SUBMISSION: WILTSHIRE
a written submission by way of objection to DA 2020/1726

Re:
29 Wandeen Road Clareville NSW 2107
DA 2020/1726

WRITTEN SUBMISSION: LETTER OF OBJECTION
Submission: Wiltshire

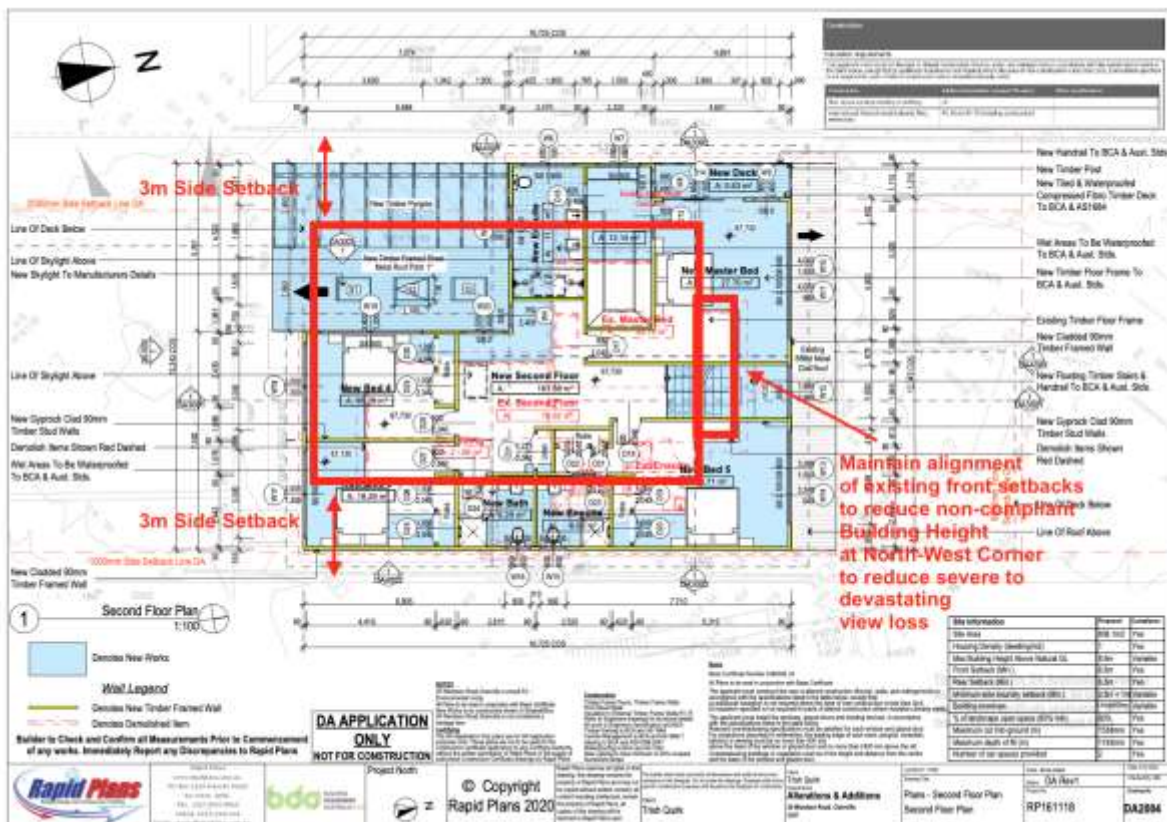
Commentary:

The non-compliant elements of the proposed development, particularly caused from the non-compliant front setbacks, the excess height, would have most observers finding *‘the proposed development offensive, jarring or unsympathetic in a streetscape context’*
